Contract # 98963

CONCRETE PARAPET SLIPFORMING OPTION

SECTION (Showing dimensions)

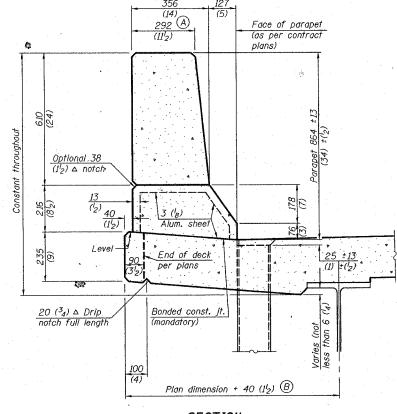
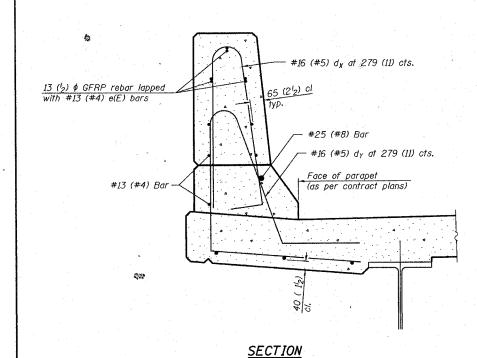
All dimensions shall remain the same as shown on contract plans, except dimensions A and B which are to be revised as shown to provide additional clearance. Additional concrete needed to revise dimension A and B= 0.0422 m /m (.0165 cu. yds./ft.) of parapet. Place aluminum sheet in curb portion at and near piers. Full thickness saw cut at all other locations. Adjust/add joint locations to maintain 3 to 6 meter (10 to 20 foot) spacing.
